# Flood Impact Assessment

Proposed Aged Care Facility at Bulli

8201813802

Prepared for  
Anglicare

Figure 6-1      Drainage Concept Plan

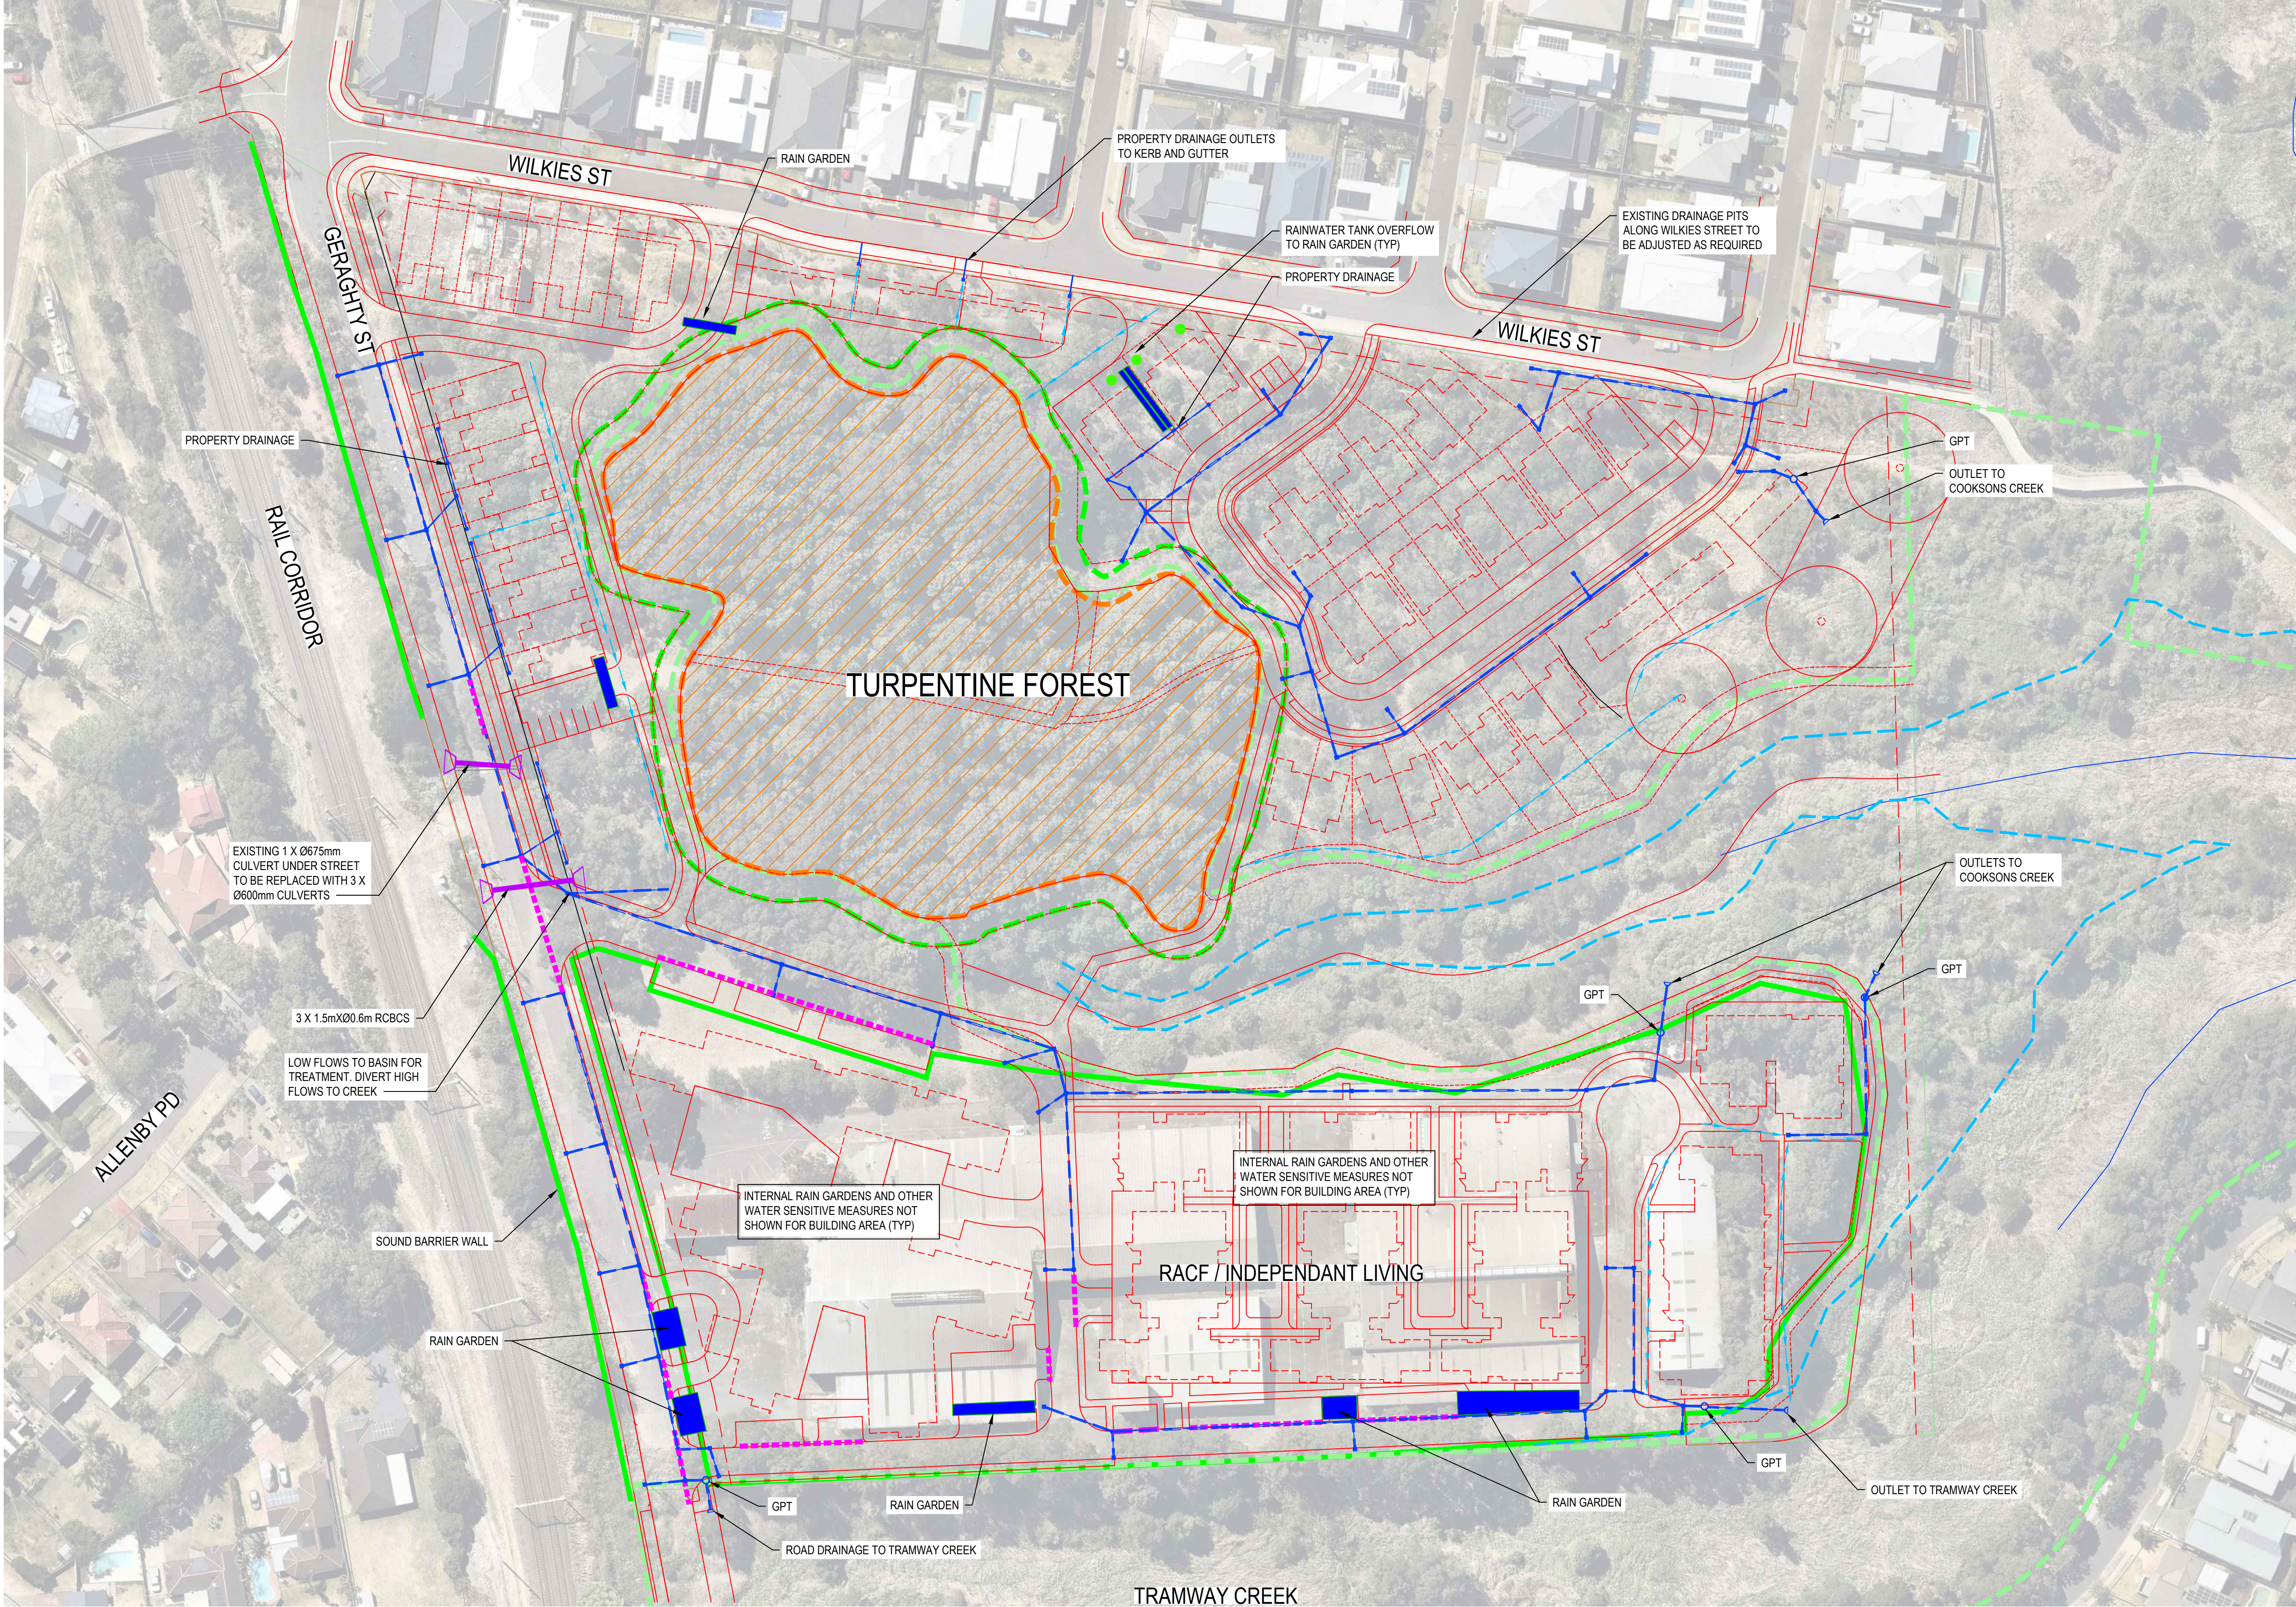
Item 7-WCC 6C	The concept stormwater plan includes works outside the site within the adjoining land (Lot 500 DP 1161858). Owners consent and an easement to drain water over the adjoining land (in accordance with Section 11.3.6 of Chapter E14 of the Wollongong DCP2009) would be required to facilitate this work.	The concept drainage plan was update to remove the works outside the site.  Refer to concept drainage plan.

Item 8-WCC 6D	The proposed road off Wilkies St (between Wakefield St and Craven St) is in conflict with an existing stormwater pit. The existing system will need to be modified and a new pit will need to be constructed by the developer as part of the works, to ensure design function of the system is maintained.	The existing drainage in Wilkies Street was updated to avoid clash with the access road. Refer to concept drainage plan.

Item 9-WCC 6E	It is unclear why On-site Stormwater Detention (OSD) is proposed. As the site is located within an OSD concession zone and runoff from the site discharges directly to receiving waters without passing through intervening property, OSD is not required for this development. However, measures to address water quality are supported subject to further detail.	OSDs were removed from the concept drainage plans
